To: Design Review Board
From: Jon Regala, Senior Planner
Date: December 10, 2012
File No.: DRV12-00921
Subject: LAKE STREET PLACE - DESIGN RESPONSE CONFERENCE
(CONTINUED FROM NOVEMBER 19, 2012)

Lake Street Place Project

Response to November 19th Design Response Conference:

1 ENLARGED PORTSMOUTH PUBLIC WALKWAY
 1" = 10'

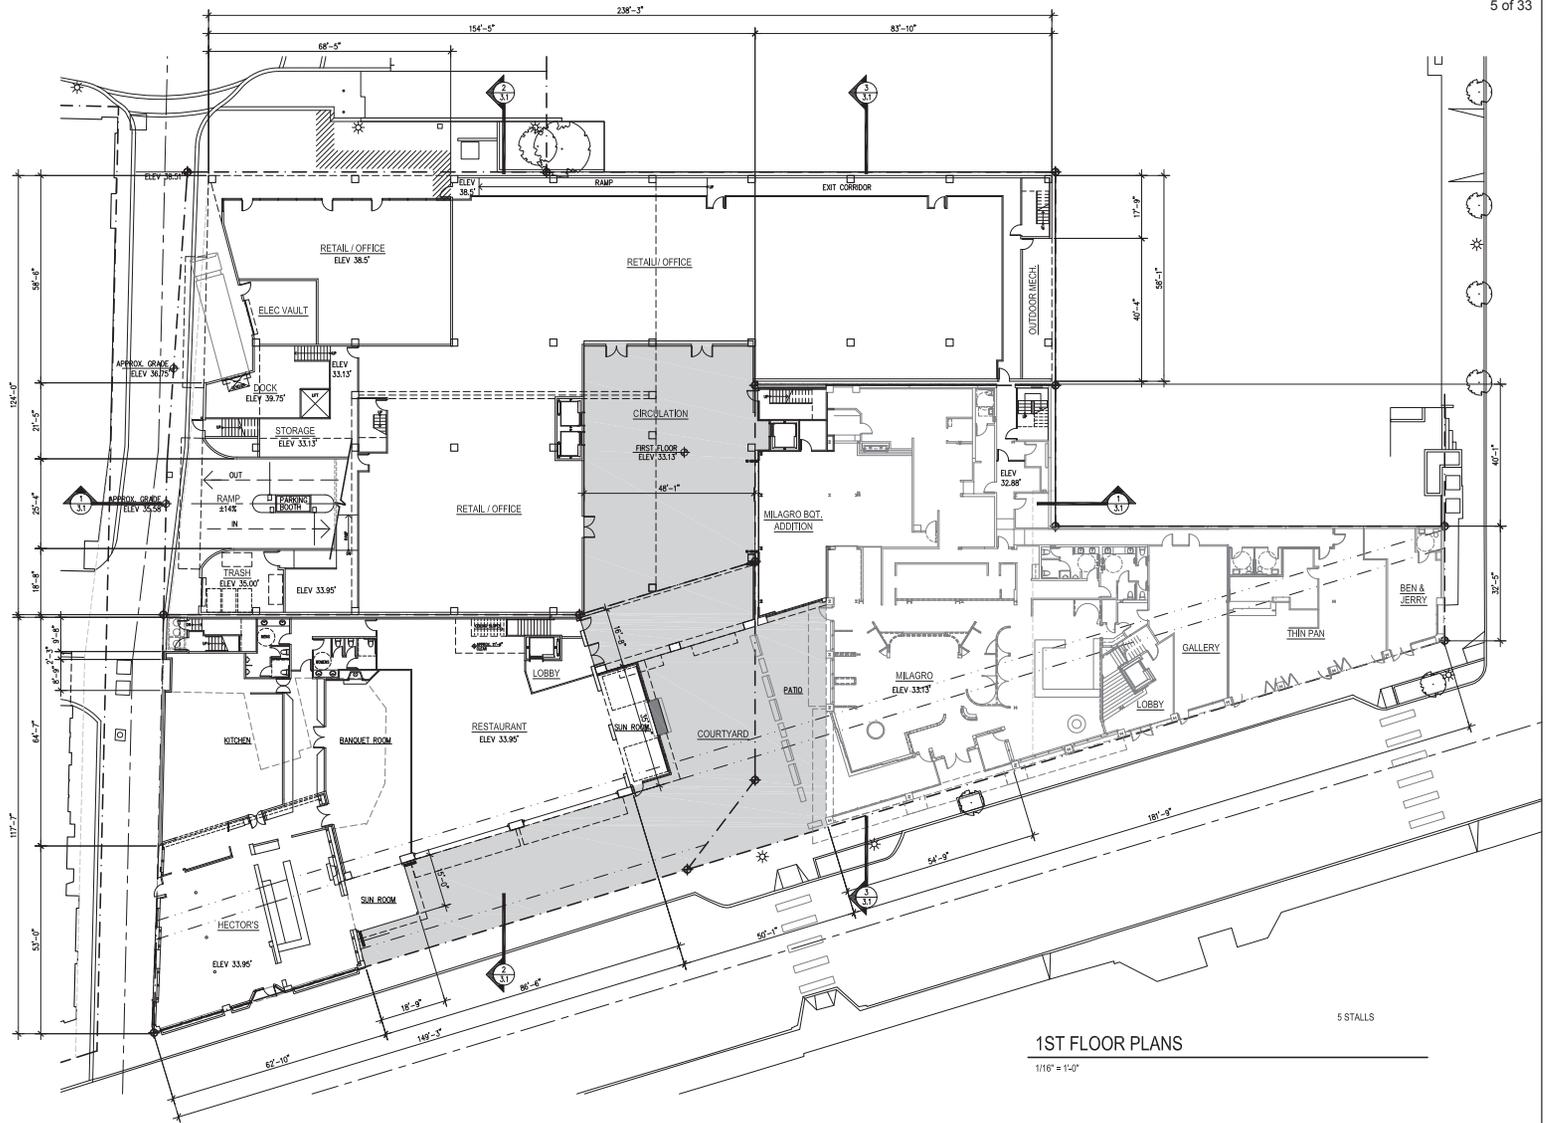
Landscape Plan Sheet L1.4 also shows landscaping located on the adjoining Portsmouth property within the public walkway. The landscaping is proposed in order to help buffer a portion of the parking garage's east wall that faces the Portsmouth condos. The DRB should however consider whether the façade treatment is satisfactory without the landscaping improvements since approval from Portsmouth has not formally been granted. If Portsmouth agrees to the improvements, the applicant should submit approval from Portsmouth in writing granting the installation of the proposed improvements. The agreement should also specify maintenance responsibilities of the proposed improvements.

In terms of improvements that may be placed in the Main Street right-of-way (near the Portsmouth stairway), Public Works would allow landscape planter areas but nothing built-up and made of concrete. Public Works would have to approve a landscape planter area on a case-by-case basis. The applicant has proposed landscaping in this area as shown on Landscape Plan Sheet L1.4.

- We have been in discussions with the Portsmouth condominiums and have agreed to add to the existing planters along the base of the new Main Street Building at the public walkway to add a softened edge and foliage along the base of the wall. The planter height of 30" plus the hedge height of 6' shortens the height of the visible wall area to 14' or so down from the overall wall height of 22' before the 10' setback from the property line at the top floor.
- The two options at the south elevation responds to the changes made to the exterior elevation at the public walkway or the southeast elevation. Please review sheet 5.0.

- The Portsmouth public walkway landscape plan is shown on sheet L1.4. We have agreed to extend the planter along the west edge of the walkway and along the base of the new Main Street building. Lighting in this area will match the existing low downlight cast into the planter walls that provide a soft light on the walking surface. We also plan to provide uplights to wash the new trees in the new planter.
